RE: St. Lucie Units 1 and 2
Docket Nos. 50-335 and 50-389
Proposed License Amendment
EDG Risk Informed AOT Extension
Request for Additional Information Response

REQUEST FOR ADDITIONAL INFORMATION RELATED TO THE AMENDMENT OF THE TECHNICAL SPECIFICATIONS FOR THE EMERGENCY DIESEL GENERATORS ST. LUCIE UNITS 1 AND 2 FLORIDA POWER AND LIGHT COMPANY DOCKET NOS. 50-335 AND 50-389

FIGURE 1
Blackout Crosstie Bus Arrangement

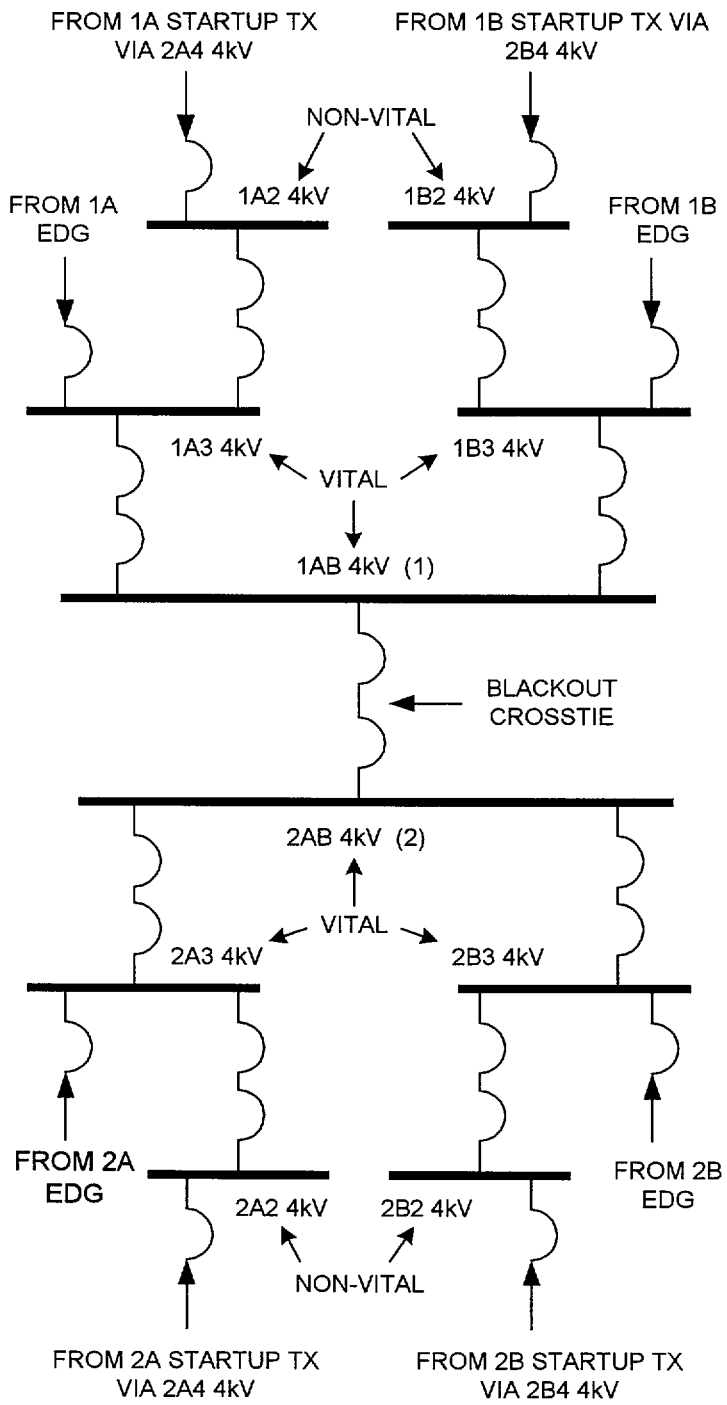
Is the crosstie recovery event failure probability (0.1) identical for both units? Explain why the asymmetry in design between the units was not captured.

The blackout crosstie recovery event probability is identical for both units. This event considers failures associated with both hardware (e.g., breaker failures) and the operator action. The design of the blackout crosstie and associated 4.16kV busses is symmetrical between the units. Figure 1 provides a simplified electrical diagram showing the blackout crosstie. The operator actions required are similar whether the crosstie is used to power a Unit 1 bus from Unit 2 or a Unit 2 bus from Unit 1. It is appropriate, therefore, to use the same blackout crosstie failure probability for both units.
